CW2144960-A010-0067_R1
1833-05-TQS-8039_0

Site Technical Query - Form

TQ Number:		Project:	
CW2144960	-A010-	0067	Oyu Tolgoi Underground Project
A. To be completed by or on behalf of the Contractor			
Contractor/Sub-Contractor Name:	MCS International	Date Response	23/02/2022
Contract Title:	Booster Fan installations	Plant Area &	1833
Contract No.	CW2144960	Contractor TQ Number:	BF-0415-TQ-0067
Discipline Codes (Mandatory) <input type="checkbox"/> D1 (CSA) - <input checked="" type="checkbox"/> D2 (MP) - <input checked="" type="checkbox"/> D3 (E&I) - <input type="checkbox"/> D4 (Other) - <input type="checkbox"/>			
<i>Description of Technical Query (List affected drawings and specifications):</i> 1833B Fan area : Monorail hoist clash issue The hand chain wheel of monorail hoists (2ea) installed on the monorail beam is clashing with shotcrete ceiling and cable bolt. Refer to the attached field photos.			
<input type="checkbox"/> Routine <input checked="" type="checkbox"/> Urgent Refer Technical Query instructions

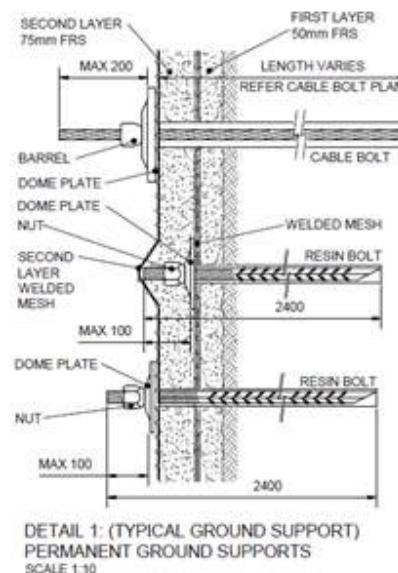
<i>Proposed Action (List all attachments)</i> The contractor is proposed the following options. 1. To cut the cable bolt, to demolish the shotcrete ceiling part and push the reinforcement mesh clashing with the hoists hand chain wheel. 2. To rotate the hoist 180 degrees and install it on the monorail beam. However, it is difficult to install isolation damper because the lifting lug of the isolation damper is 350 mm from the wall. (Refer to the attached pictures) Or, The Company to advise alternative option.			
Effect on cost (USD):	NO		
Effect on schedule (Days):	NO		
Effect on quality:	NO		
Requested by (Name):	Delgersuren.N	Position:	SMP Engineer
Signature:		Date: (dd/mm/yyyy)	19/02/2022

Option #1 is acceptable subject to steps as follows:

1. Chip second layer of shotcrete up to first layer welded mesh within red highlighted area in below photo;
2. Make sure not to damage the welded mesh while chipping;
3. Push welded mesh tight against ceiling with additional Hilti anchors and small plate as required;
4. Cable bolt is to be re-tensioned by OT Geotechnical team after chipping of shotcrete. Contractor to coordinate with Worley field supervision and Geotechnical engineers;
5. Cut a cable bolt tail beyond the nut maintaining 50 mm after re-tension of the cable bolt.

Note that the following steps are to be made until there will be no clash.

Option 1

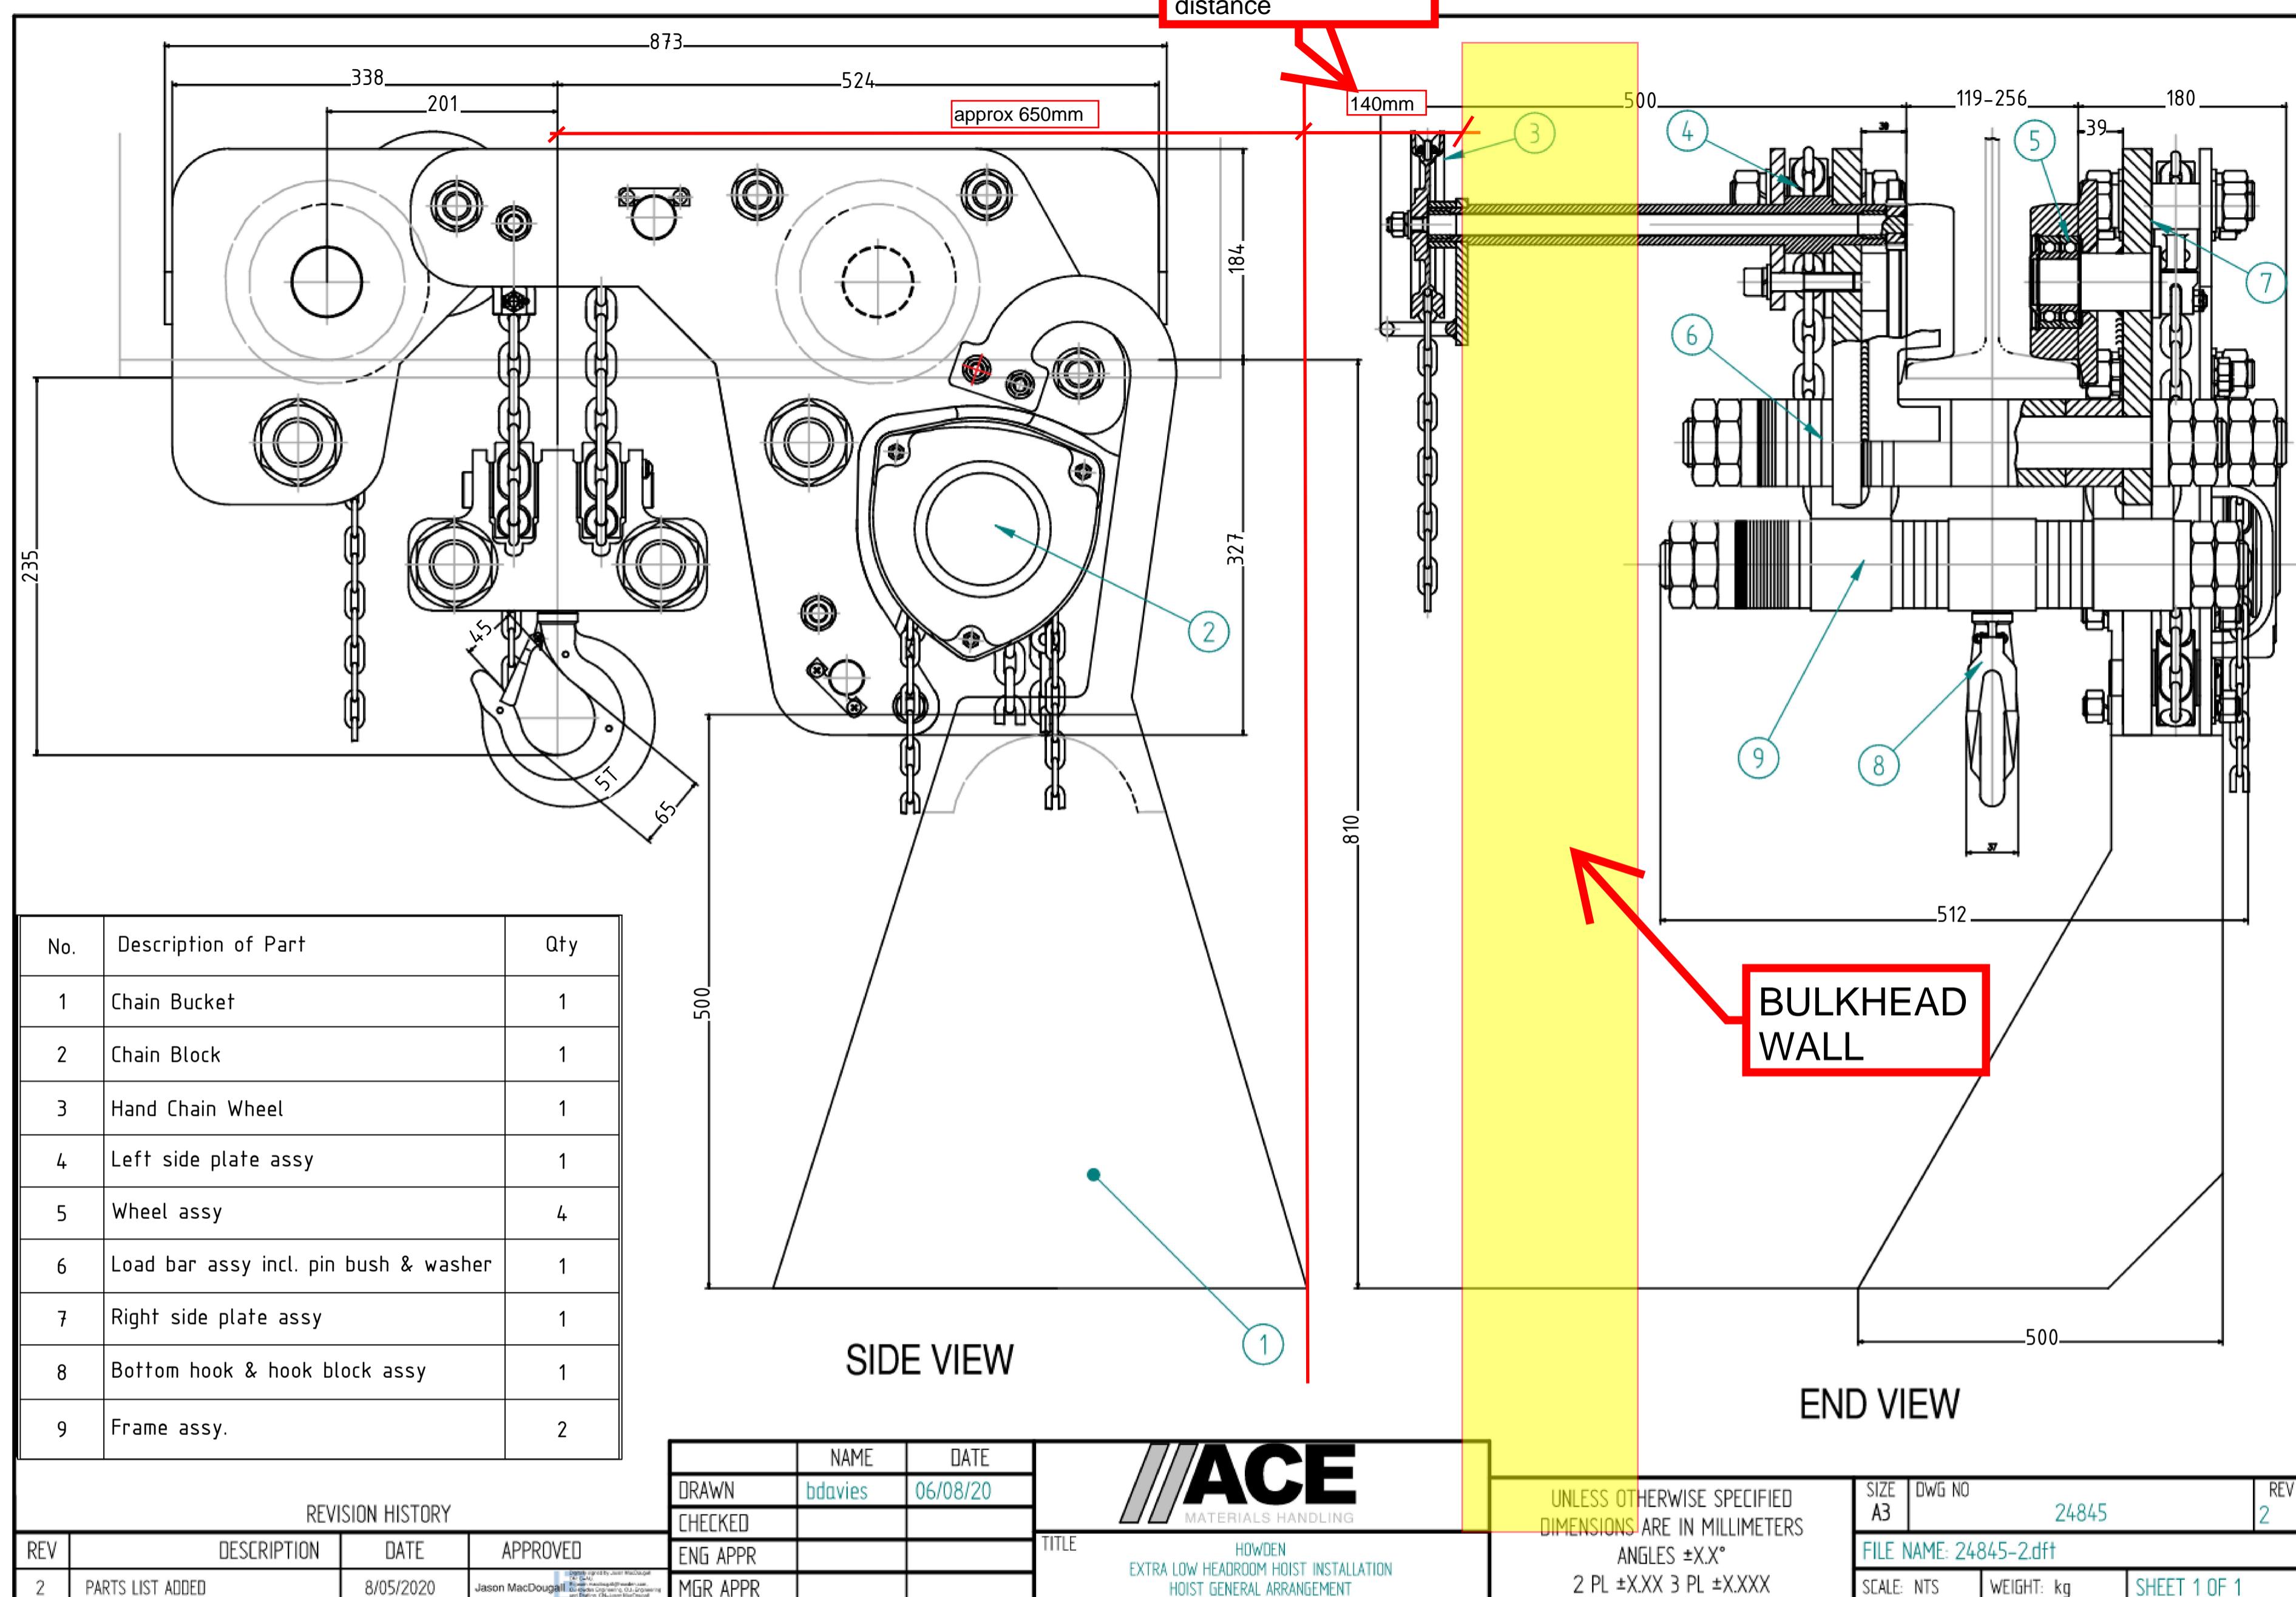
Cable bolt is
clashed with
monorail hoist.

Remove
the washer

To cut the
cable bolt

To demolish the
shotcrete ceiling
part and push the
reinforcement
mesh

Shotcrete ceiling
clashed with hoist
